Docket No. 52-021  
MHI Ref: UAP-HF-10148

**Subject: Transmittal of Markups of US-APWR DCD Chapter 15.6.5 Small Break LOCA**

**Markups of US-APWR DCD Chapter 15.6.5 Small Break LOCA**

**15.6.5 Loss-of-Coolant Accidents Resulting from Spectrum of Postulated Piping Breaks within the Reactor Coolant Pressure Boundary**

Figure 15.6.5-21 PCT at All Elevations for Hot Rod in Hot Assembly for 7.5-inch Small Break LOCA

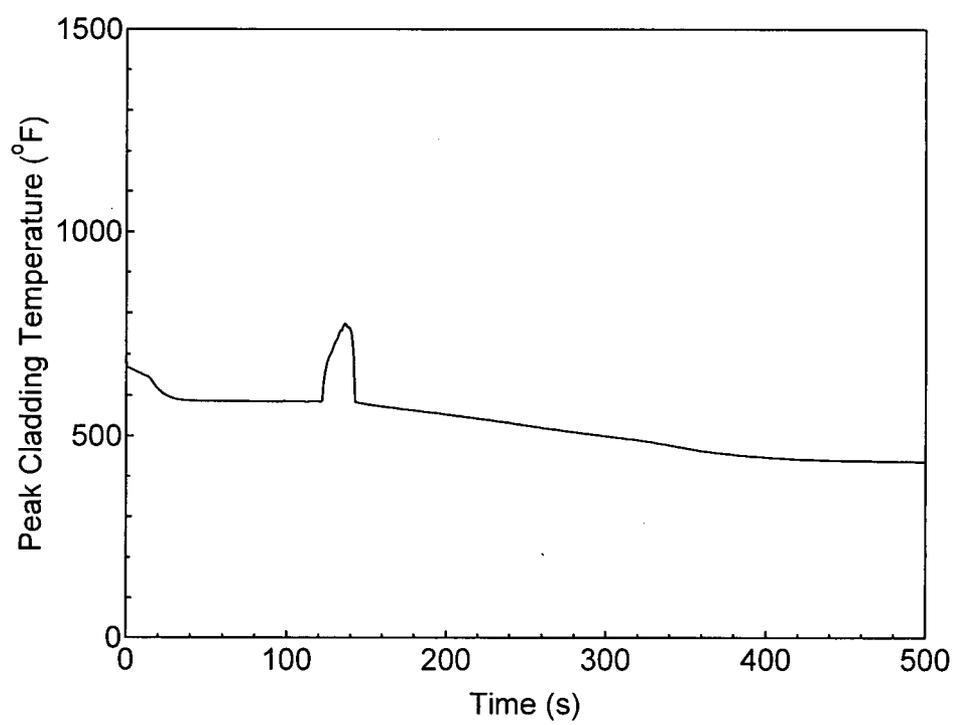
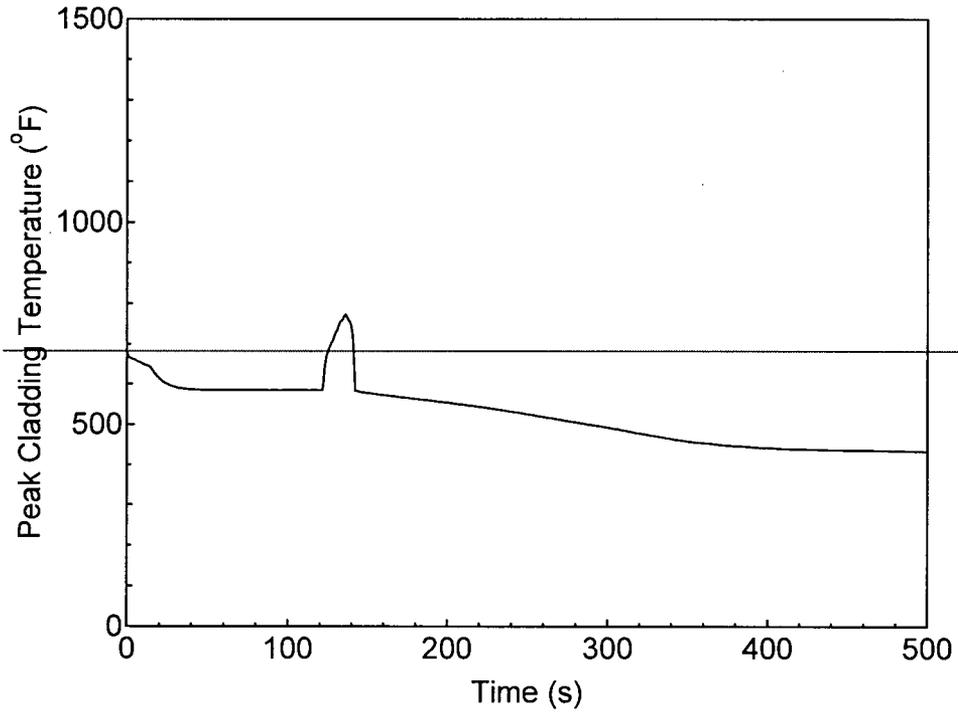
Figure 15.6.5-21 shows the PCT at all elevations for the hot rod at the maximum allowed linear heat rate and the average rod in the hot assembly that contains the hot rod. The PCT of ~~773~~775°F occurs at 136 seconds. This figure demonstrates that the PCT is substantially lower than 2200°F.

Figure 15.6.5-30 PCT at All Elevations for Hot Rod in Hot Assembly for 1-ft<sup>2</sup> Small Break LOCA

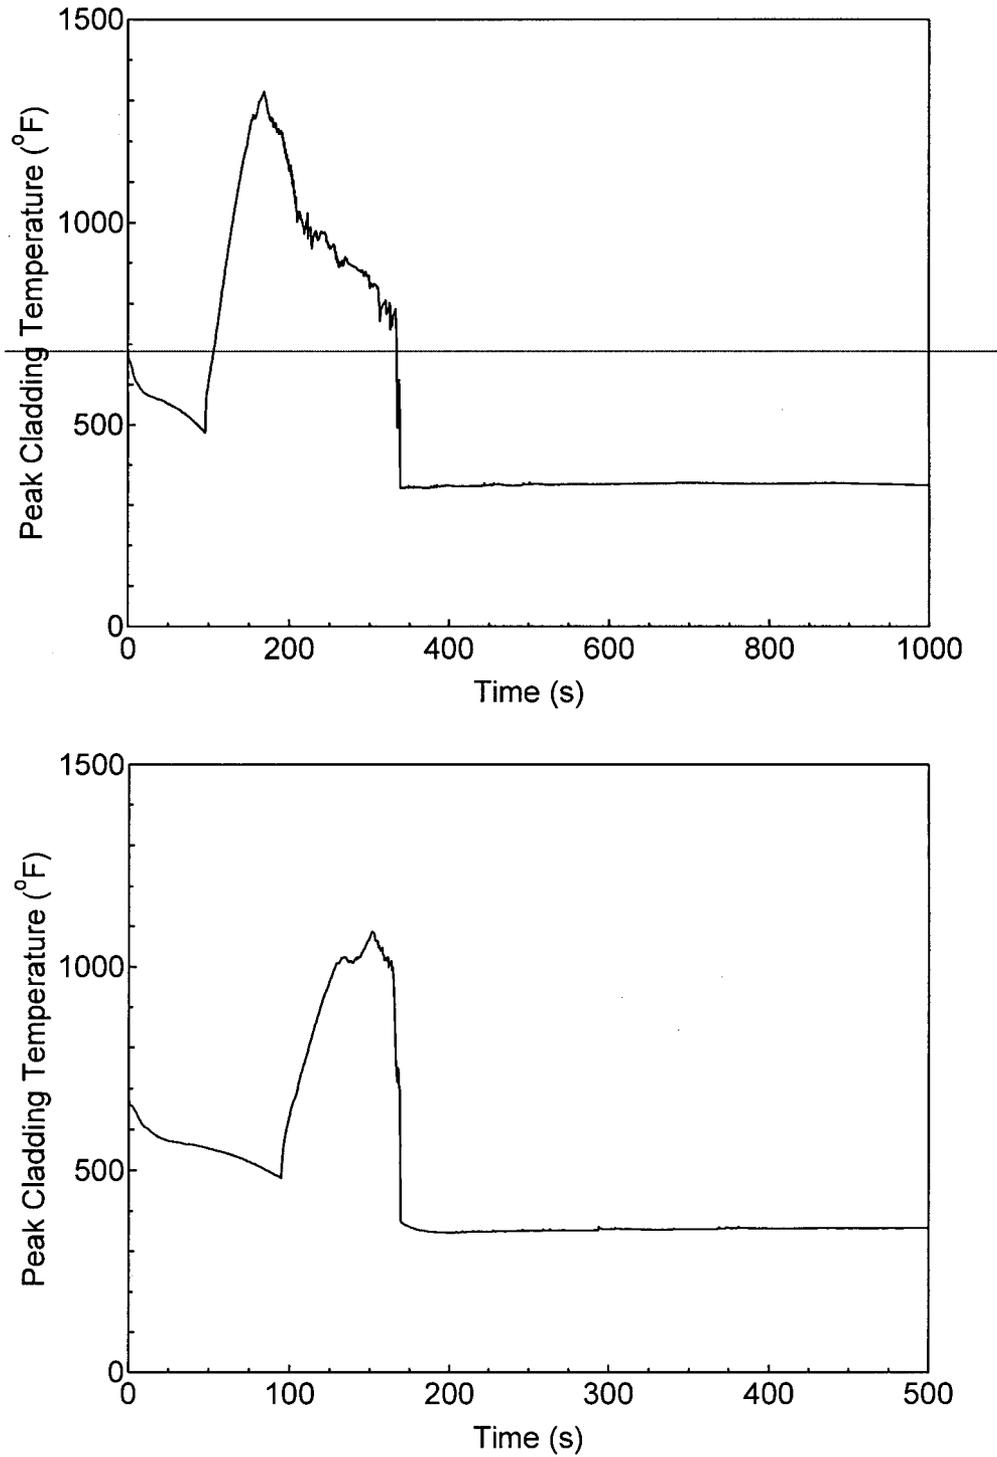
Figure 15.6.5-26 shows the accumulator and safety injection mass flow rates. The accumulators begin injecting borated water into the cold-leg at 80-89 seconds. The HHIS begins to inject borated water to the reactor core at 126 seconds. As a result of ECCS injection, the mass inventory is recovered. Figure 15.6.5-27 shows the RCS inventory transient. The downcomer liquid collapsed level and core/upper plenum liquid collapsed level transients are shown in Figures 15.6.5-28 and 15.6.5-29, respectively. Figure 15.6.5-30 shows the PCT at all elevations for the hot rod at the maximum allowed linear heat rate and for the average rod in the hot assembly that contains the hot rod. This figure shows that the PCT of 1323-1088°F occurs at 149-151 seconds. The PCT is significantly lower than 2200°F.
